**PLANNING DEPARTMENT ADMINISTRATIVE PUBLIC HEARING
SUMMIT COUNTY, UTAH
March 6, 2025**

- 1.A. **949 Empire Avenue – Historic District Design Review** – The Applicant Proposes to Construct a New Single-Family Dwelling on a Vacant Lot in the Historic Residential - 1 Zoning District. PL-24-06355.
(A) Public Hearing; (B) Action

Subject: 949 Empire Avenue
Application: PL-24-06356
Author: Meredith Covey, Planner I
Jacob Klopfenstein, Planner I
Date: March 6, 2025
Type of Item: Historic District Design Review

Figure 2: Planning Director setback determination

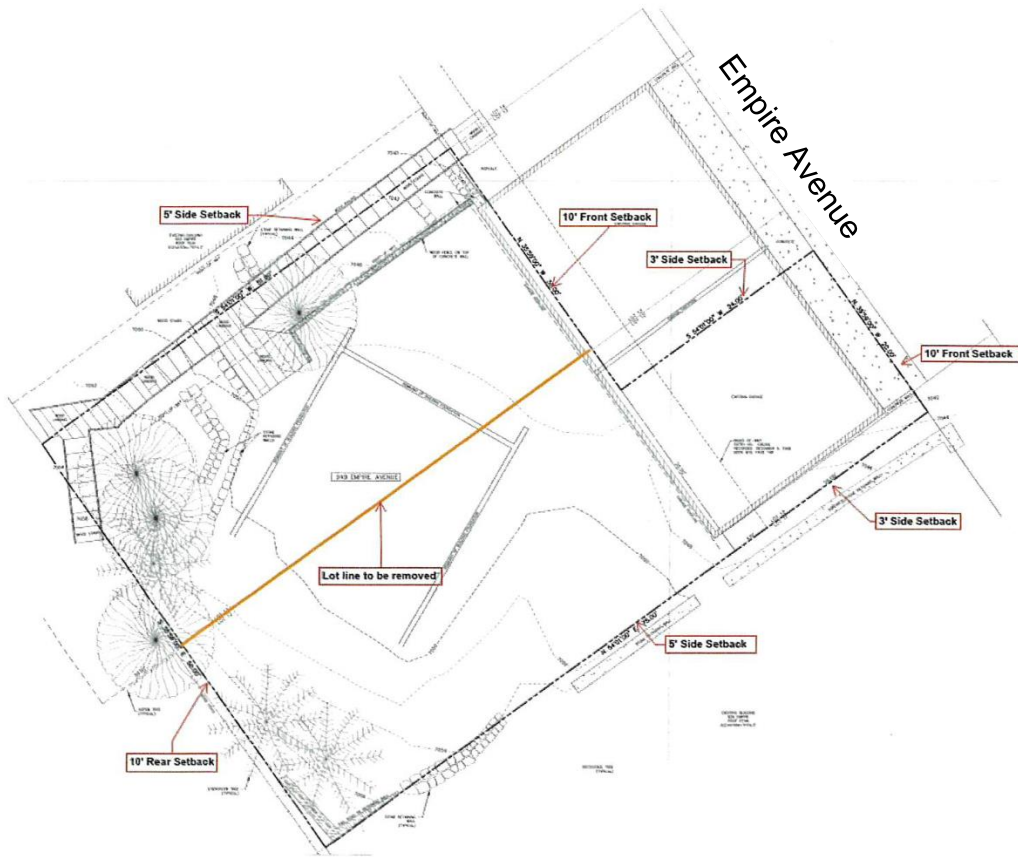
There are existing stairs on the Lot mostly in the North Side Setback, and partially in the Rear Setback. The use of the stairs is private and was dedicated for the benefit and use of the owners of Lots 12, 13, 14, 15, 17, 18, 19, 20, 21, and 22 of Block 9 of Snyder's Addition to Park City. The Lot has six property lines that measure: 50', 51', 30', 24', 20', 75'. Due to the unusual Lot dimensions, the Planning Director determined Setbacks (see also Exhibit D):

- Two 3' Side Setbacks;
- Two 5' Side Setbacks;
- Two 10' Front Setbacks;
- One 10' Rear Setback.

Building Height

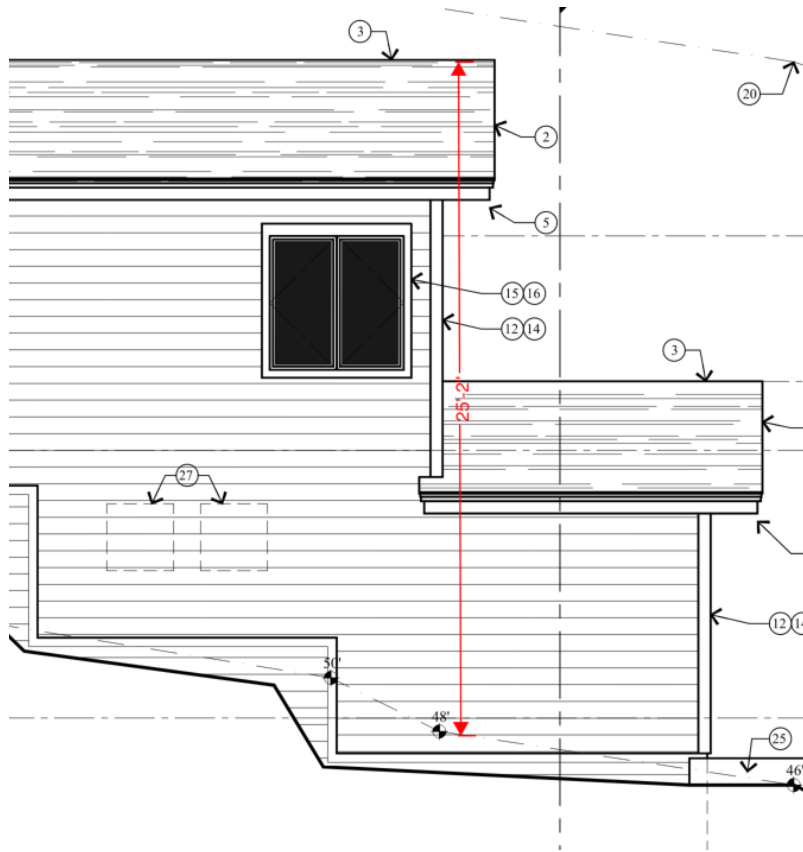
Pursuant to LMC § [15-2.2-5](#) no Structure shall be erected to a height greater than twenty-seven feet (27') from Existing Grade. The proposed Structure is 25 feet 2 inches in height when measured from Existing Grade and is compliant.

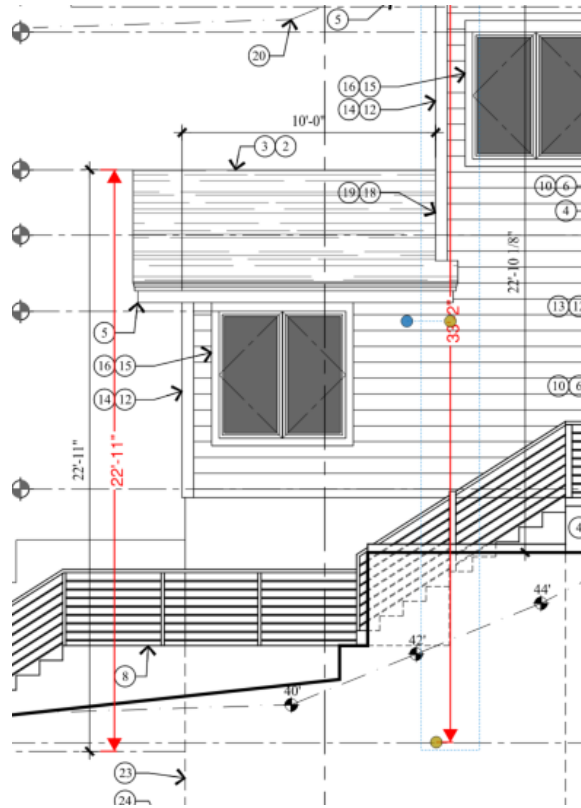
Pursuant to LMC § [15-2.2-5](#) a ten foot (10') minimum horizontal step in the downhill façade is required unless the First Story is located completely under the finish Grade on all sides of the Structure. The horizontal step shall take place at a maximum height of twenty-three feet (23') from where the Building Footprint meets the lowest point of Existing Grade. The proposed Structure steps down 10 feet at 22 feet 11 inches above grade and is compliant.

Interior Building Height

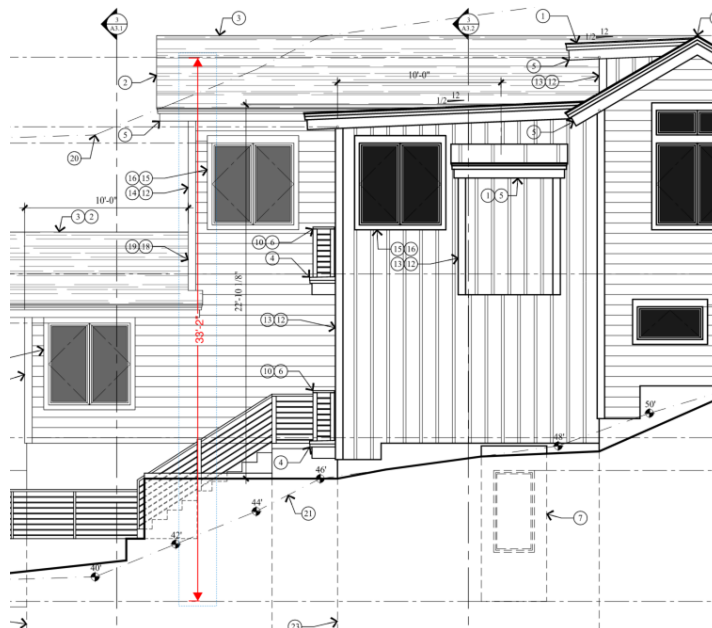
Pursuant to LMC § [15-2.2-5\(A\)](#) a Structure shall have a maximum height of thirty five feet (35') measured from the lowest finish floor plane to the point of the highest wall top plate that supports the ceiling joists or roof rafters. The proposed Structure has a maximum interior height of 33 feet 2 inches and is compliant.
